**DELEGATED REPORT****TO:** SENIOR PLANNER**FROM:** Planning Officer**FILE:** OPW/18/0014**DATE:** 4 December 2018**APPLICATION DETAILS**

The development application seeks a Development Permit for Operational Works (Roadworks, Stormwater, Water Infrastructure, Drainage and Earthworks) for Development Permit REC/06/0108.

COLIN EMERY  
 HILLTOP CLOSE SUBDIVISION  
 KURANDA LOT 84 ON SP237138  
 SUBDIVISION WORKS

**From:** Michael Lancini  
**Sent:** Monday, 19 November 2018 5:58 PM  
**To:** Carl Ewin <CarlE@msc.qld.gov.au>  
**Cc:** Roger McLeod <rog@pottsvillebeachrealestate.com.au>; Bob Pentecost <Bob.Pentecost@cardno.com.au>; Sam Wakeford <SamW@msc.qld.gov.au>; Victor Madrid <VictorM@msc.qld.gov.au>  
**Subject:** RE: Hilltop Close / Hastie Road Operational Works Application

Plan 1003 – Site Plan:

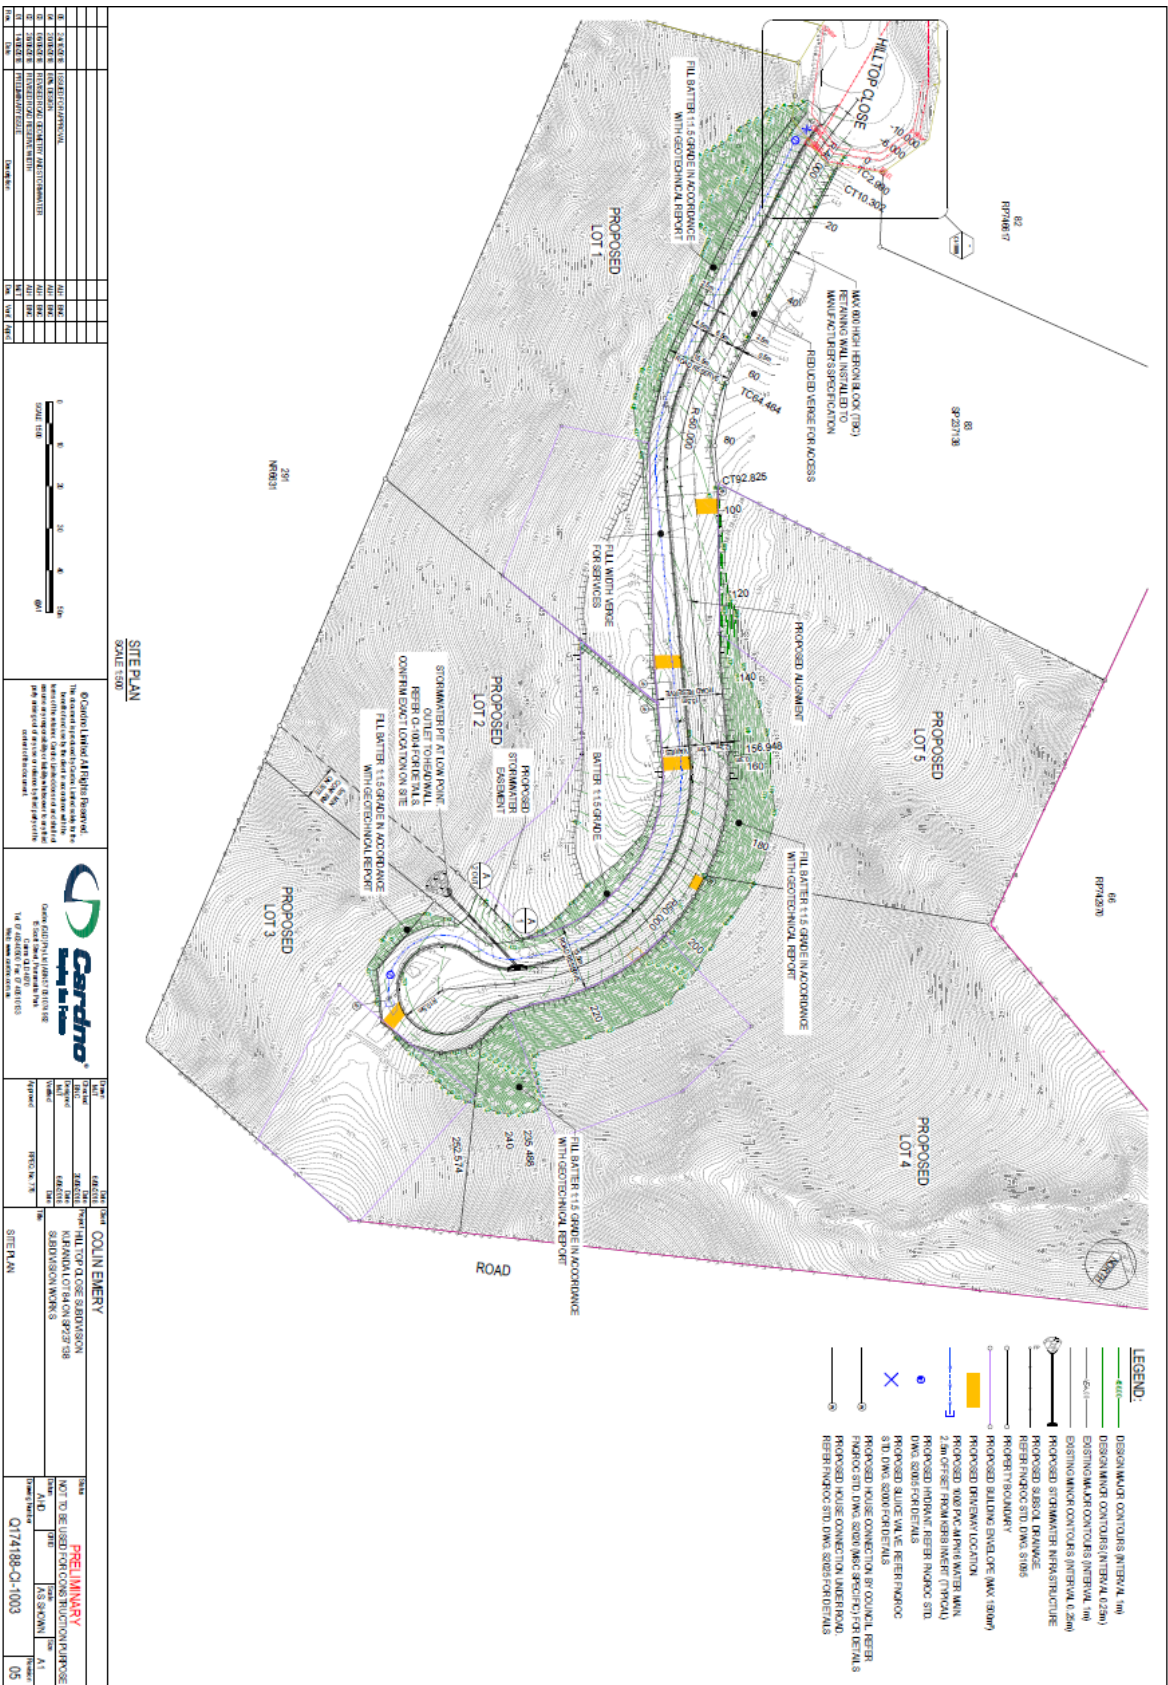
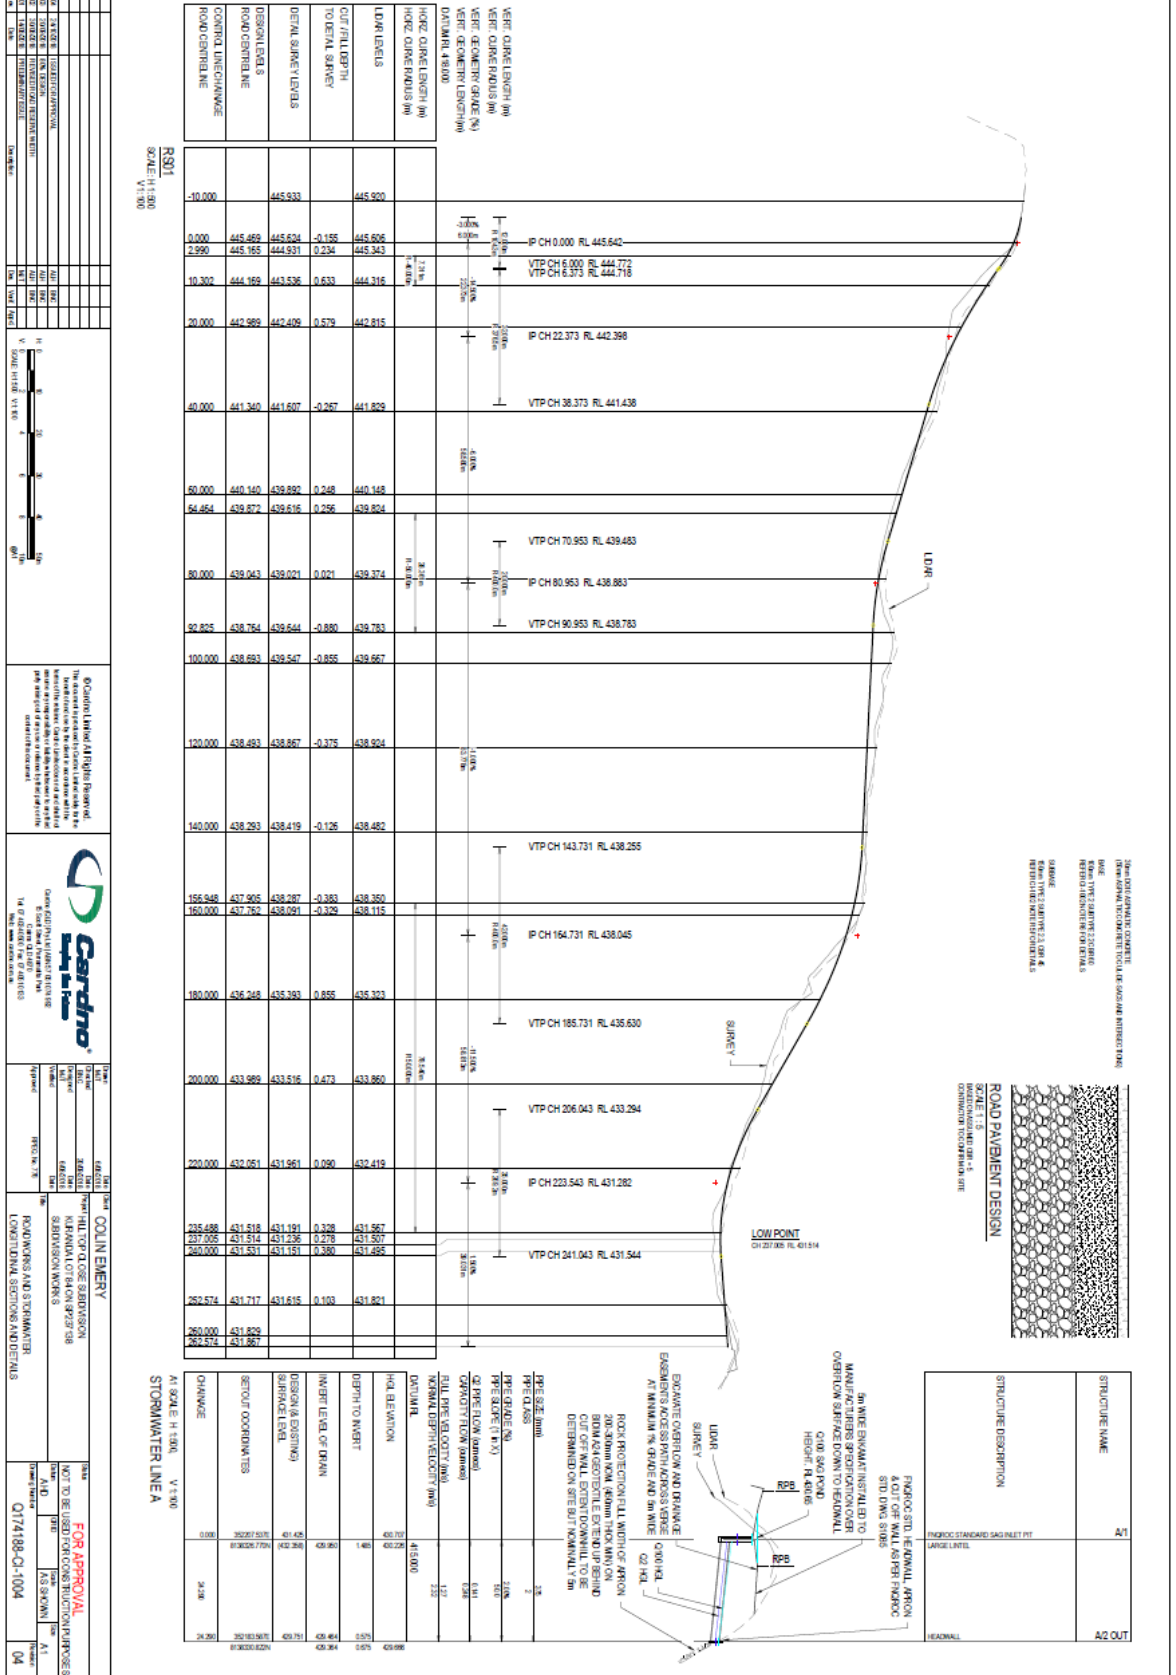
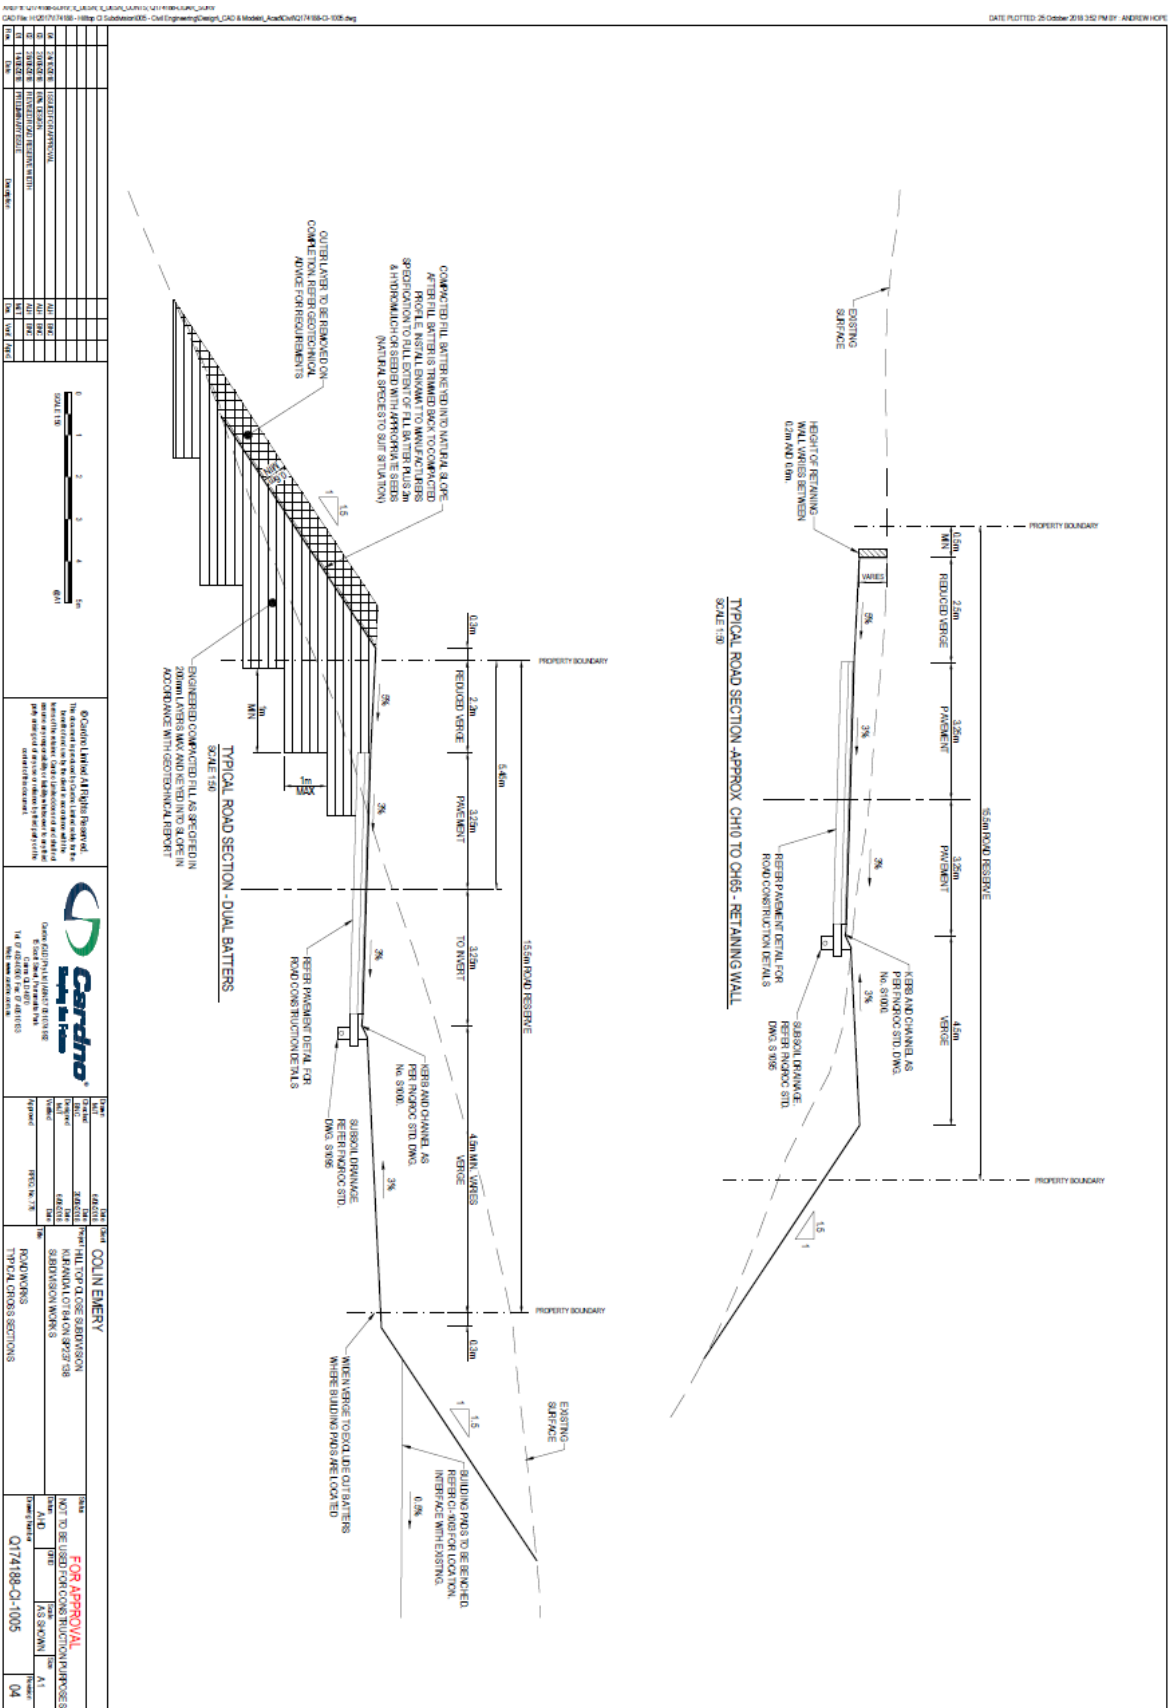
- All Cut batters to be constrained within the lot, not to extend into road reserve. **The verges will be increased in width to ensure that the cut batters are not in the road reserve.**

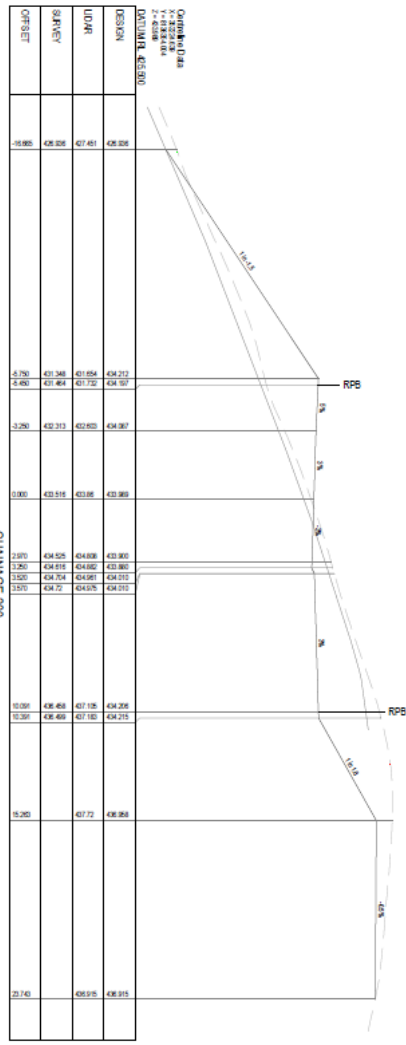
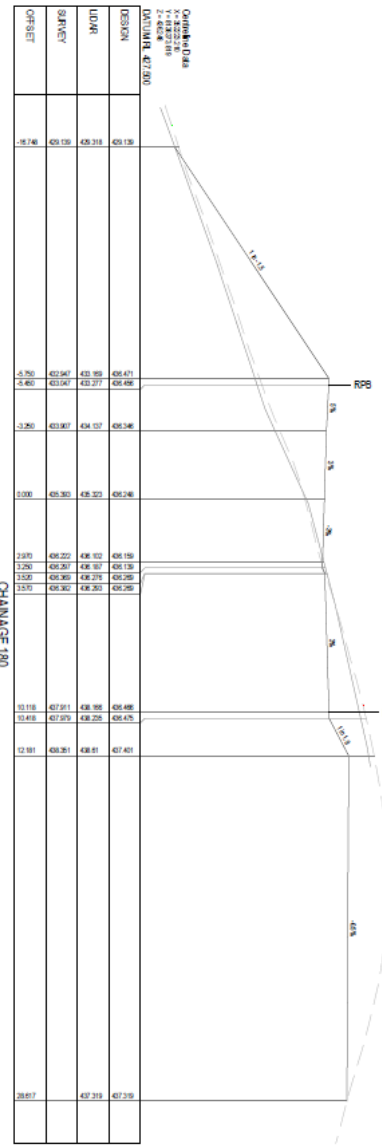
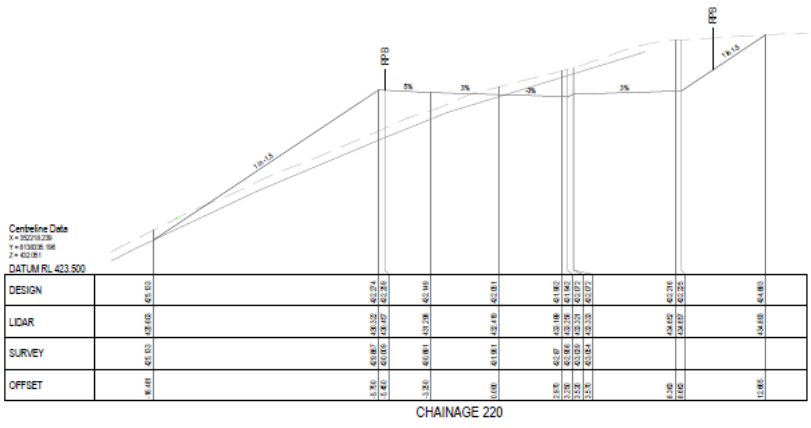
3. Chainage 0 to 80 – RHS Batter is within Road Reserve, anyway to put in protections for council on its long term maintenance ? **The batter will be constructed with the Enkamat and hydromulched as per the “Typical Road Section – Dual Batters” on drawings CL-1005.**
